RE: **Andalucia Phase 2 – 6500 Coors NW**
Grading Plan
Engineer's Stamp Date 5/3/17
Hydrology File: E12D015D

Based upon the information provided in the submittal received on 5/5/17 the above-referenced Grading Plan is not approved for Building Permit. The below items must be addressed prior to approval:

C-100

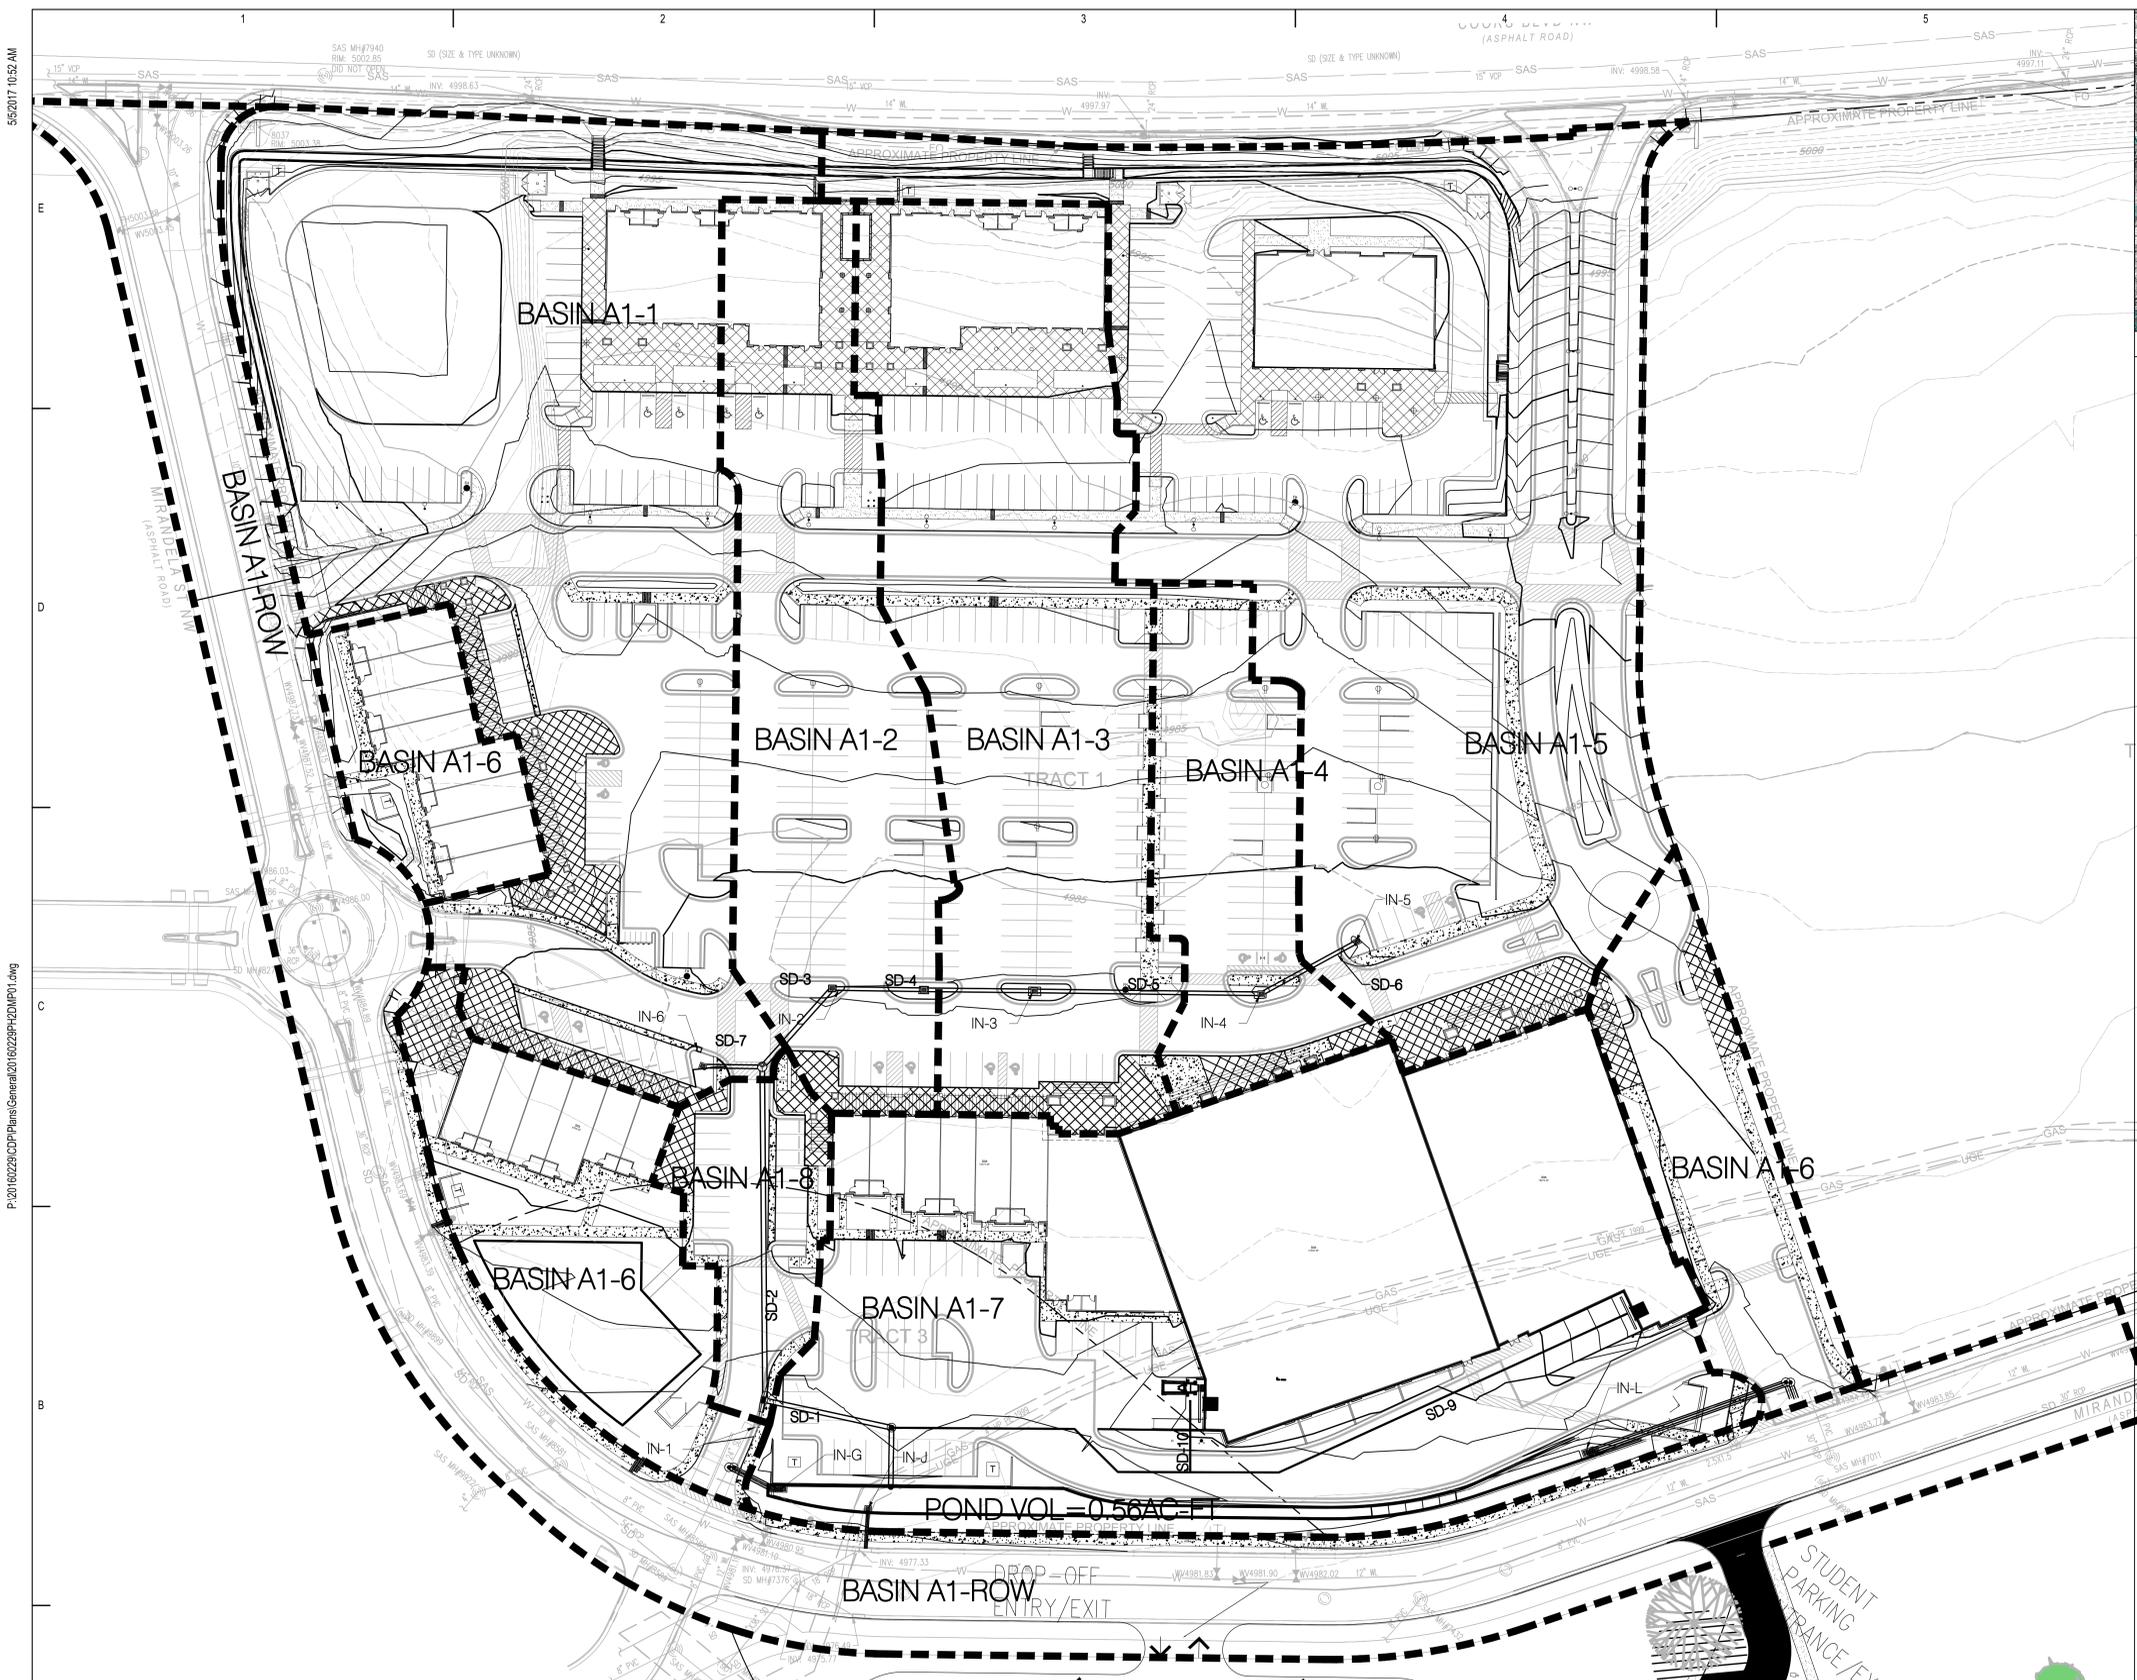
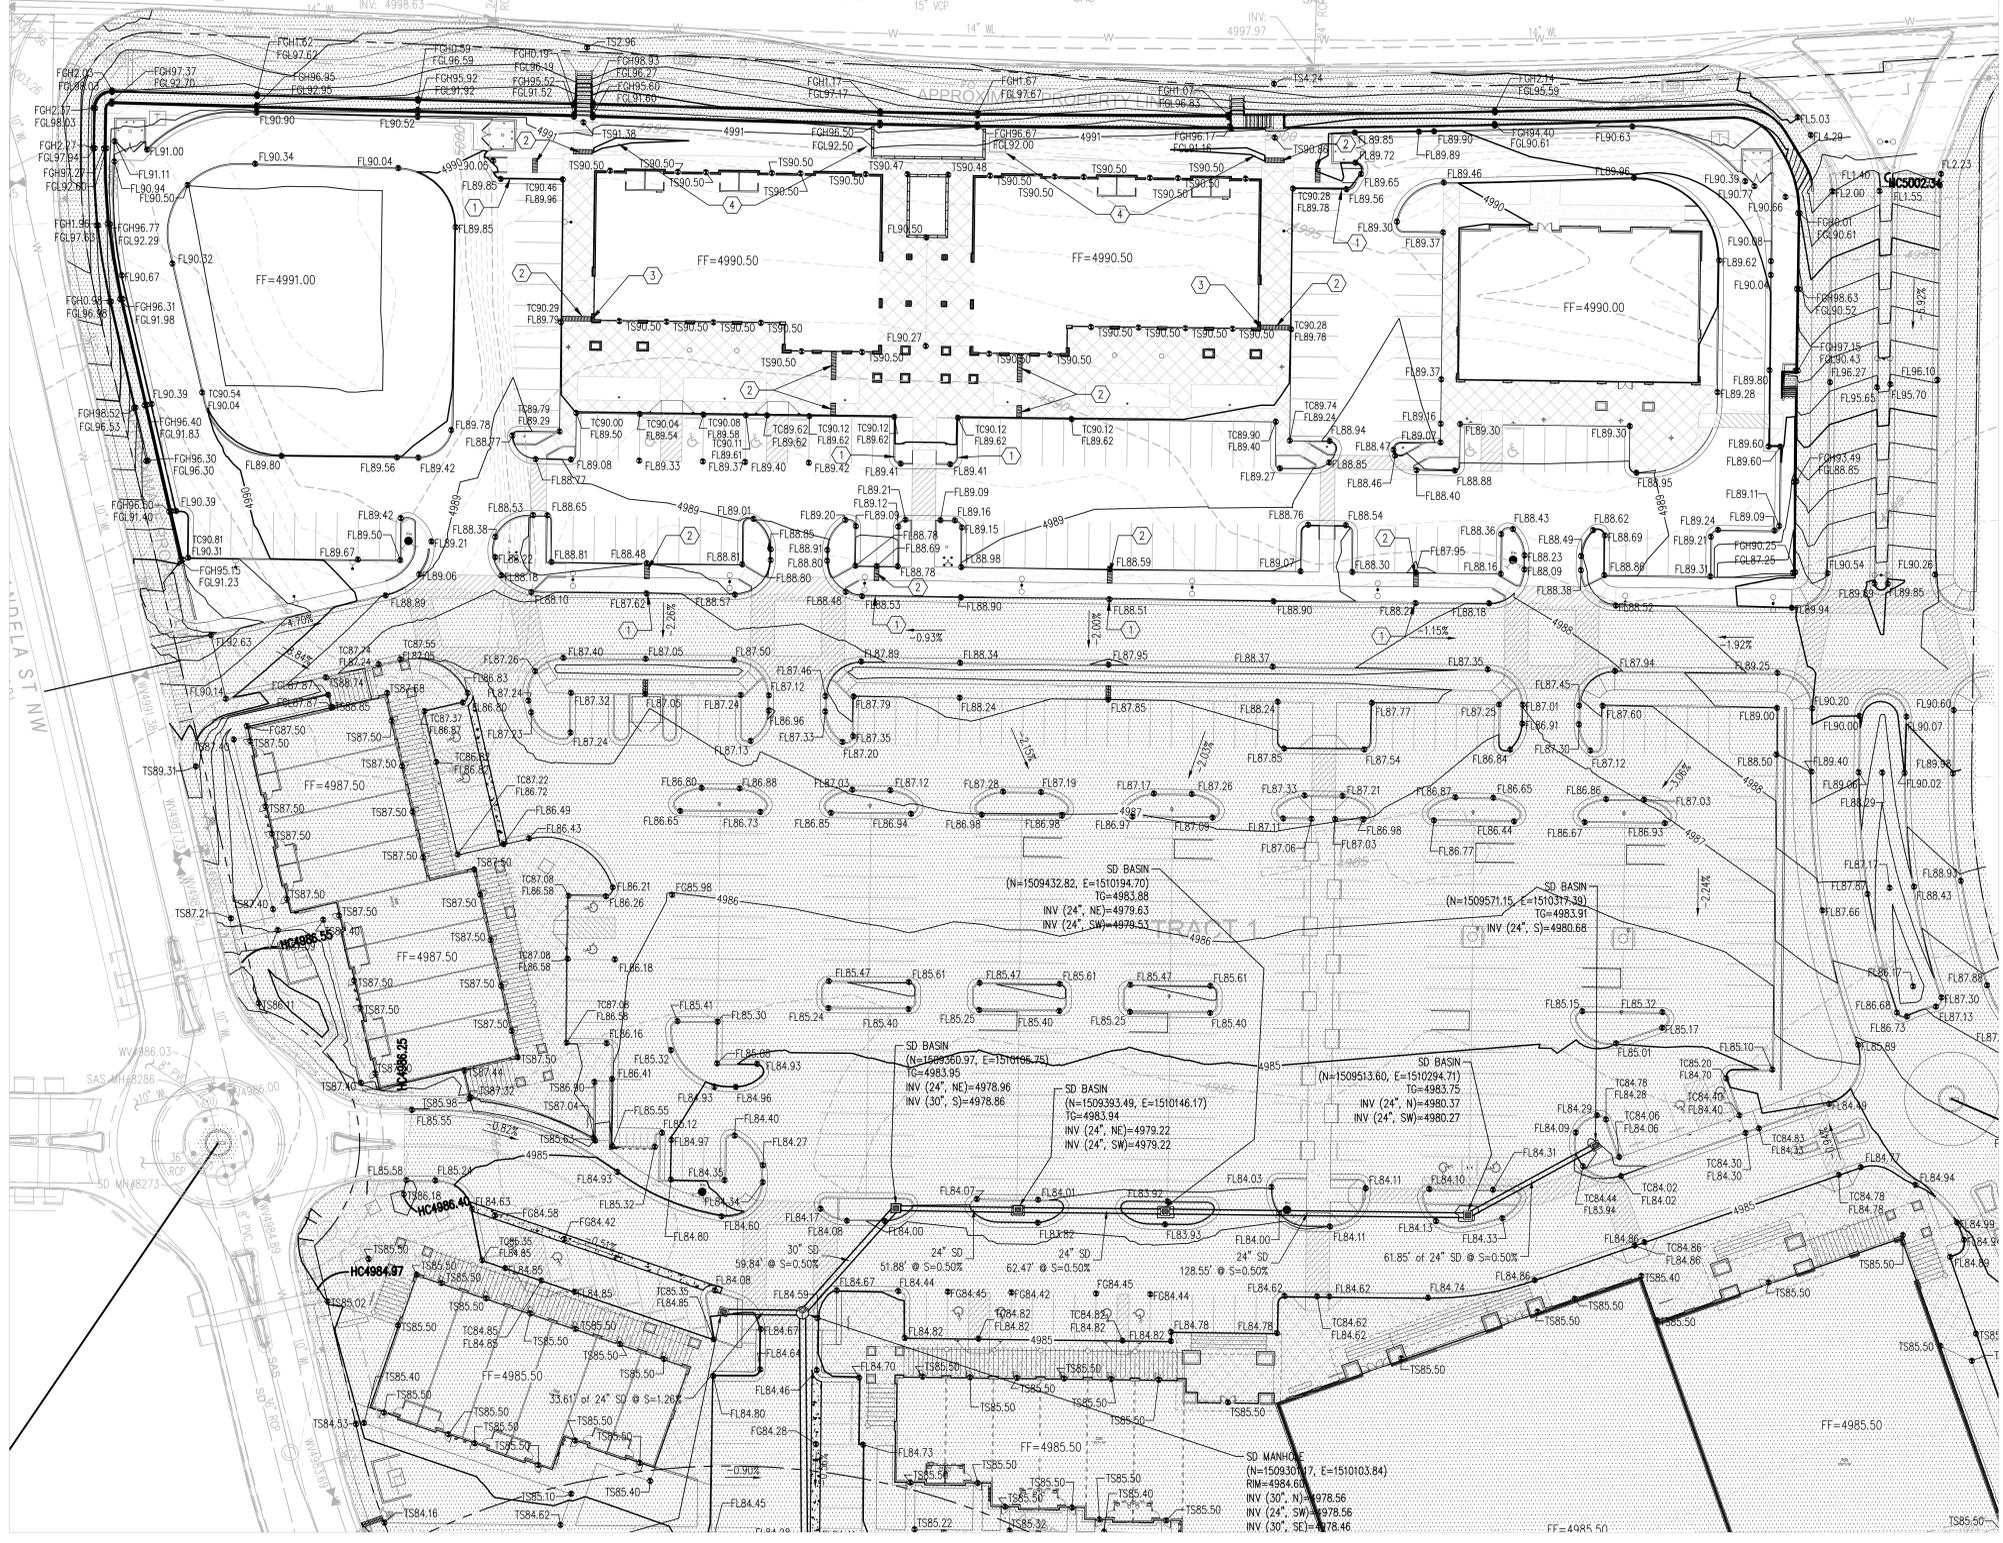
1. This project will require an ESC Plan to be submitted to the storm water quality engineer, Curtis Cherne, PE, prior to Building Permit Approval. The Phase 1 ESC Plan is not applicable for Phase 2 as it uses Phase 2's project area as staging grounds.
2. The restaurants/retailers need to be labeled as such. The dumpsters for the restaurants need to be contained, drained through a grease trap, and into the sanitary sewer.

C-100

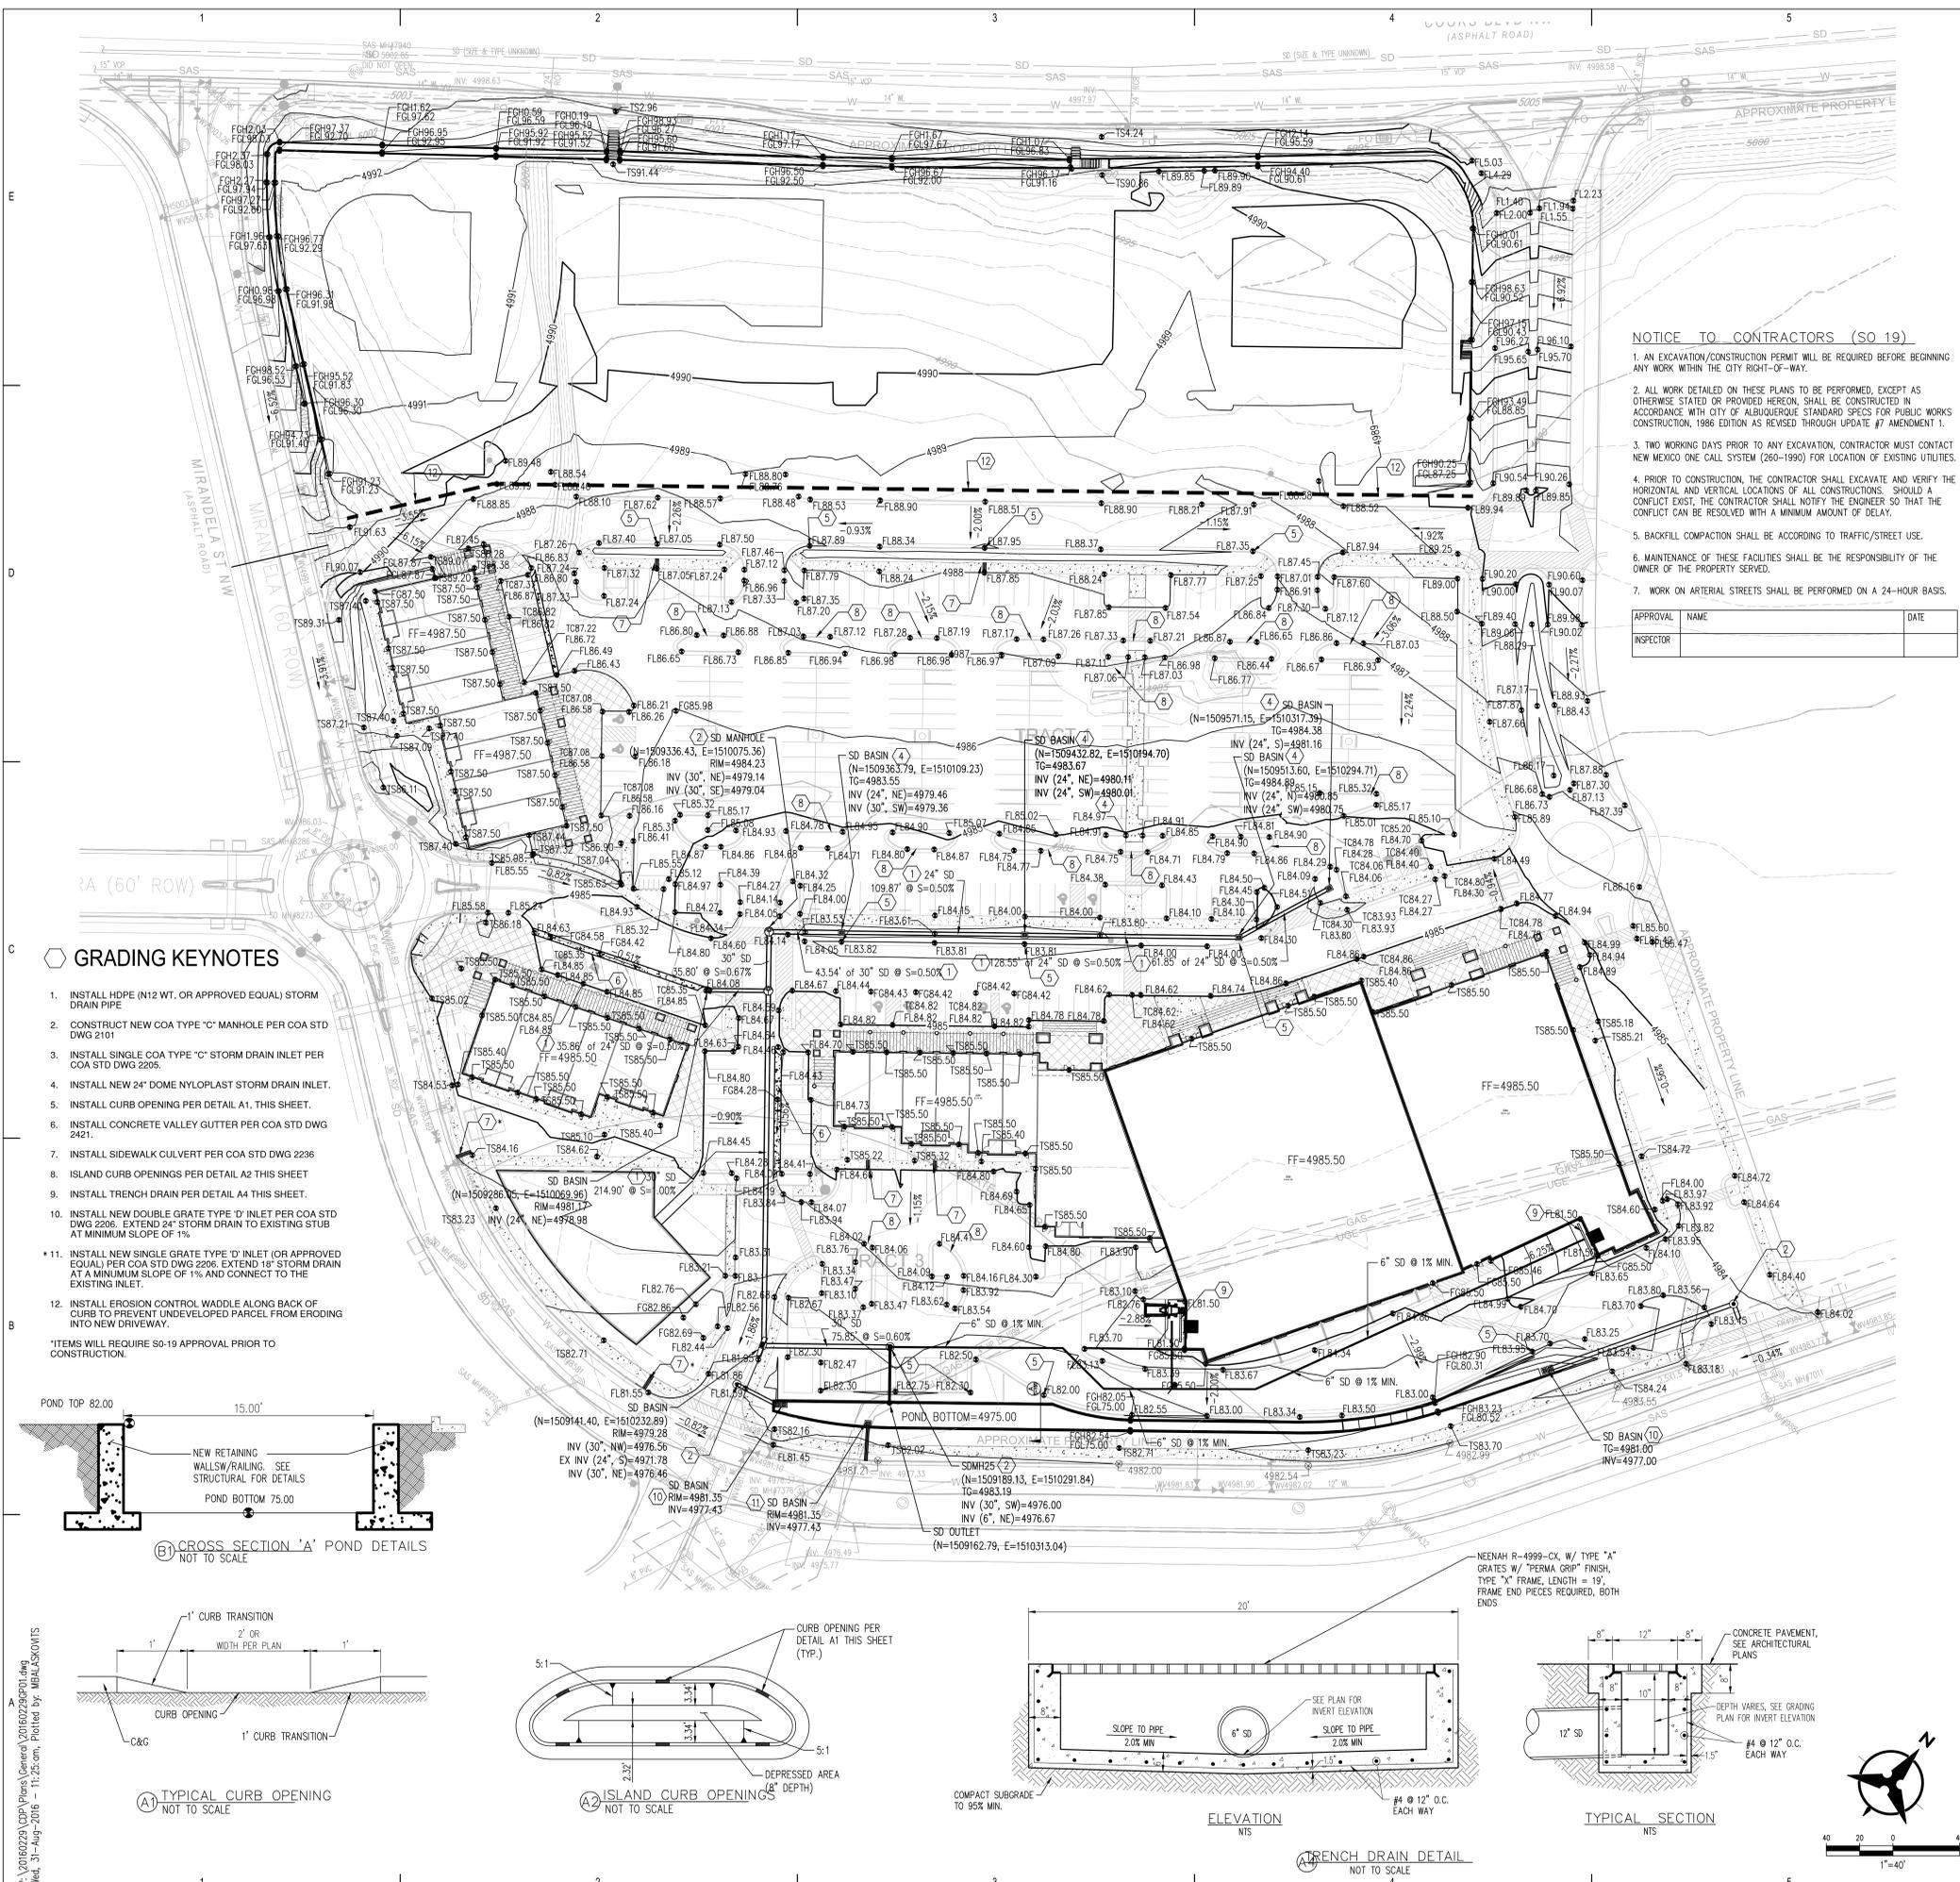
- The bottom of the pond will need to be lowered to 74.50 to allow for 0.5 ft of freeboard. The inlet grate elevations will need to be lowered (80.85), as well as the corresponding inverts.
- Inlet at north side of pond-lower the inlet grate elevation to match the other inlets
- Provide curb openings along median on private road on north side of site

1. The bottom of the pond will need to be lowered to 74.50 to allow for 0.5 ft of freeboard. The inlet grate elevations will need to be lowered (80.85), as well as the corresponding inverts.
Response: This is being addressed prior to the Certificate of Occupancy release.
2. Inlet at north side of pond-lower the inlet grate elevation to match the other inlets.
Response: This is being addressed prior to the Certificate of Occupancy release.
3. Provide curb openings along median on private road on the north side of site.
Response: This is being addressed prior to the Certificate of Occupancy release.
